# Hi-Fi Products Service Bulletin

**Model:** MDS-501

**No.** 417

**Subject:** Track name does not appear  
Applicable Serial no. 504,899 and lower

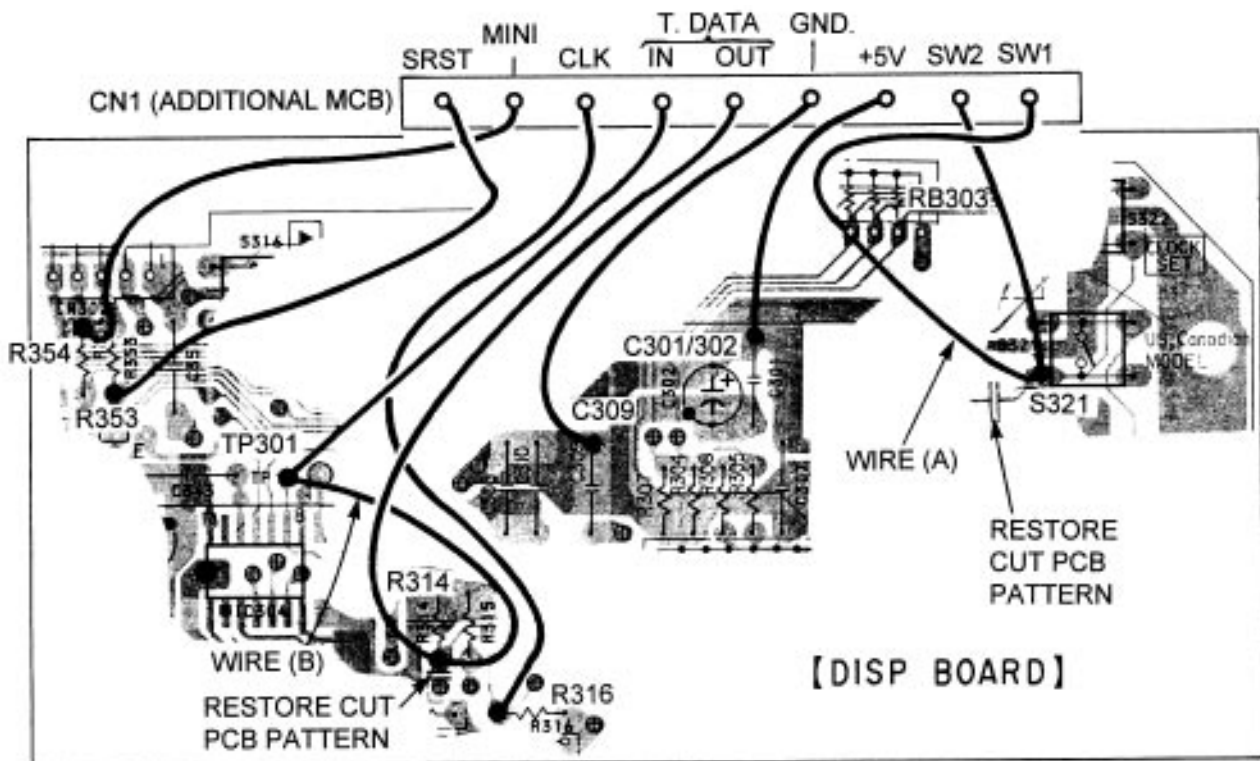
When selecting the last track by quickly rotating the Jog dial, the name of the last track does not appear and "No Name" is shown in the display.

Replace the System controller (on the display board), IC301, M38197MA-071-FP with the improved version M38197MA-076-FP. In addition you must remove the small board located between the Digital board and the Mechanism. Remove both the board and its lead wires. If attached, remove the jumper wires from the Display board and restore the PCB patterns that have been cut (See diagram). Failure to restore the patterns will result in faulty clock and date operation. Note that on some sets there are no patterns cut, instead two jumper wires are missing on the Display board (one jumper is located near S321 and the other near R314). In this case attach the missing jumper wires.
